Replacing A111 with A121

The A121 Pulsed Coherent Radar Sensor shares PCB layout footprint with the A111 Pulsed Coherent Radar Sensor but encompasses a lot of new functionality and features. **The A121 sensor can be mounted onto an existing PCB for the A111 without any layout updates, given that the existing A111 HW Integration includes a crystal with resonance frequency 24MHz.** It is however possible to improve the BOM cost if the PCB layout is updated. Note that the software libraries and software APIs have been updated and applications must be updated or rewritten for the A121.

Figure 2 The A121 recommended HW integration when connected to a host MCU running at 1.8V. For details regarding the component values in above figures, refer to A111 and A121 datasheets [1], [2].

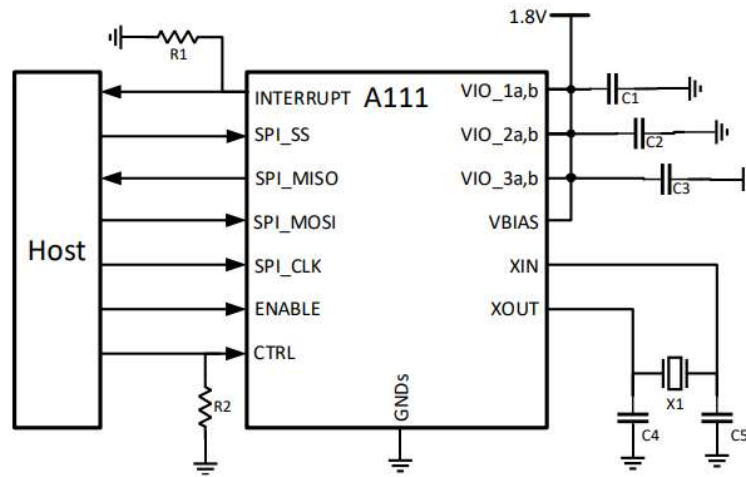
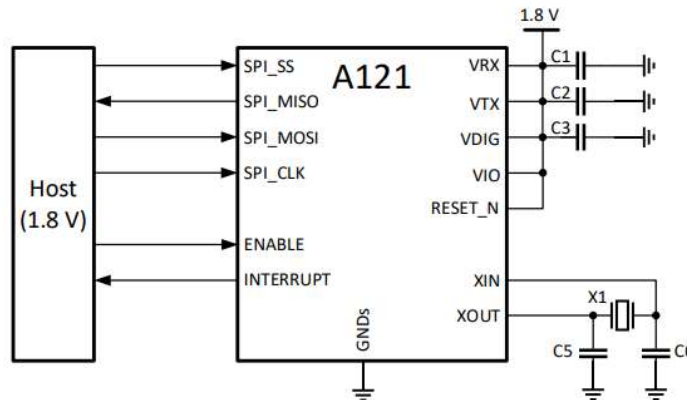
As can be seen in Figure 1 and Figure 2 where the A111 and A121 recommended HW Integrations at 1.8V are shown, both A111 and A121 require an external crystal (X1) to be able to operate:

The A121 only supports a crystal with resonance frequency of 24MHz, as opposed to A111 that also supported other frequencies. In A121 SW it is not possible to configure the frequency of the input clock.

Figure 4. Power supply integration of the A121 for minimizing the leakage current of VRX and VTX when ENABLE signal is low. For VIO = 1.8 V, VIO can be connected to the same 1.8 V power domain as VDIG, VRX, VTX.

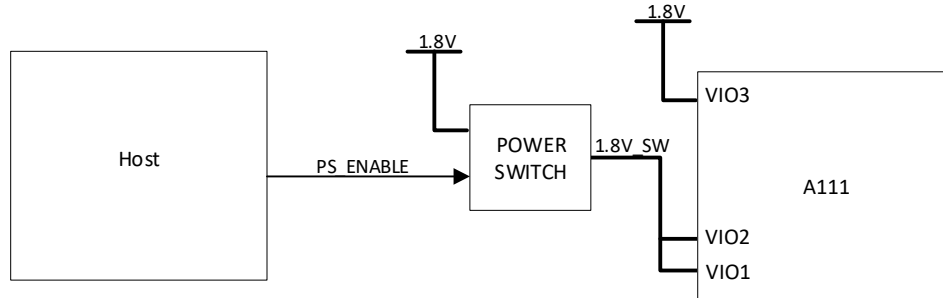
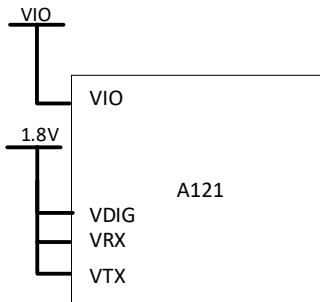
If you have a power switch to cut off the voltage supply to VIO1 and VIO2 when the ENABLE signal is low in your A111 HW integration, this component can be removed for the A121. The reason is that the leakage current of VRX and VTX of A121 is less than 1  $\mu\text{A}$  when the ENABLE signal is low (compared to  $\sim 66 \mu\text{A}$  for A111 VIO1 and VIO2). Figure 3 shows what the integration might look like for A111. Figure 4 shows what the integration with A121 could look like.

Figure 6. An example of A121 integrated with a 3.3 V host MCU.

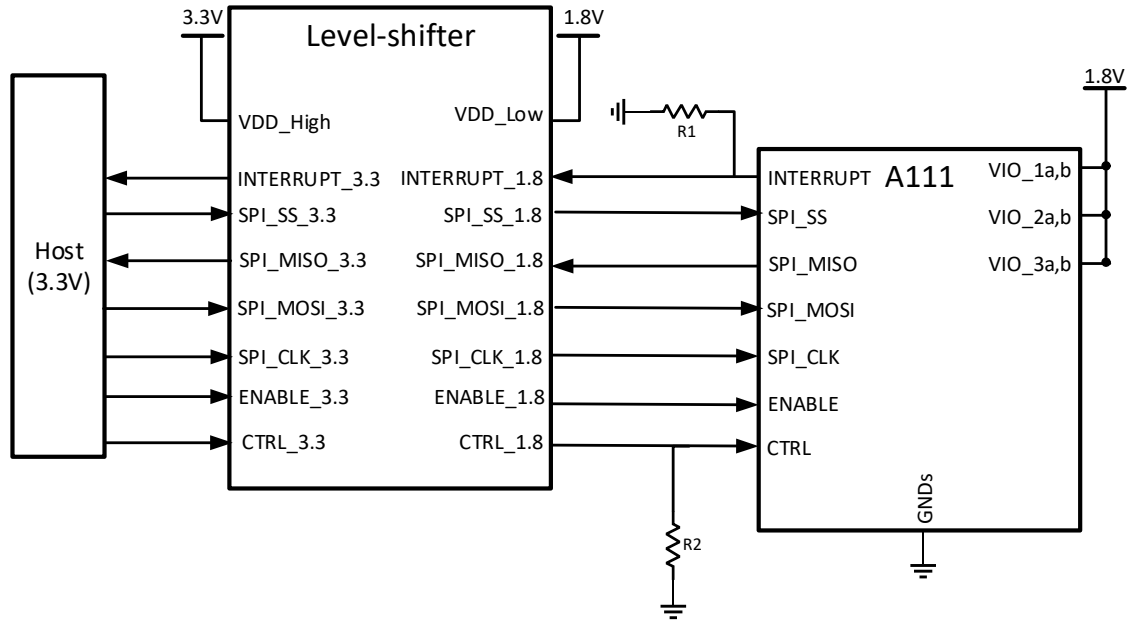
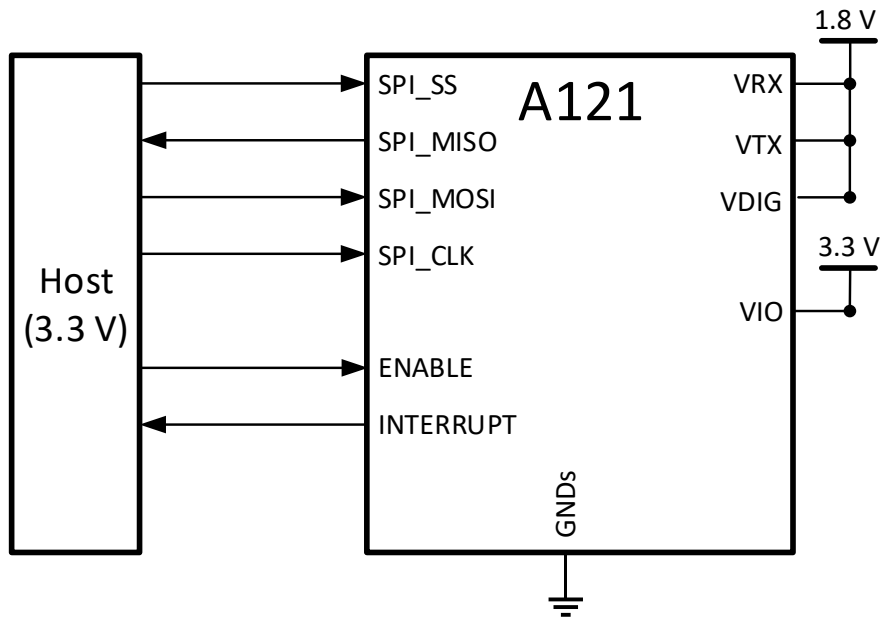
If your host MCU is operating at another voltage than 1.8 V, your A111 hardware integration includes a level-shifter circuit to convert the SPI and GPIOs for 1.8 V operation. The A121 VIO power domain can however be supplied by either 1.8 V or 3.3 V and therefore the SPI and GPIOs of the A121 can be connected directly to the host MCU without the need for a level shifter.

Figure 5 shows a block schematic of an A111 HW integration using a bidirectional level-shifter circuit. Figure 6 shows the A121 HW integration where no level-shifting circuit is needed.

Figure 7. The top layer ground plane of the XM124 module with A111 (left) and XM125 with A121 (right).

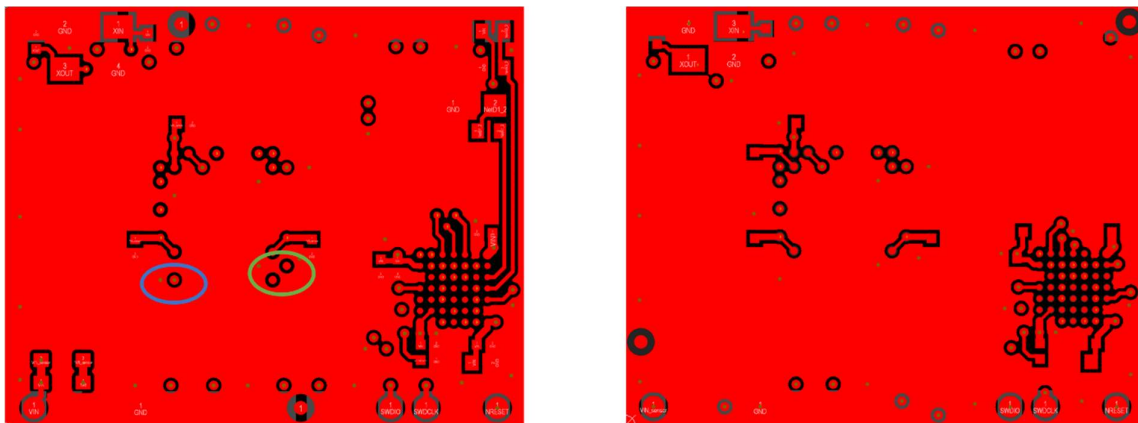
In A111, the A2 and B1 pads must be left unconnected to ensure proper operation of the radar sensor. In A121, these pads can be either unconnected or connected to ground. To optimize the ground plane of the A121, it is recommended to connect these pins to ground. The green circle in Figure 7 shows the difference in ground plane when these pins are unconnected (left-hand side picture) and connected to ground (right-hand side picture). The blue circle shows the CTRL pin A9 breaking up the ground plane in the left-hand side picture. In A121 (right-hand side picture), CTRL is connected to ground.
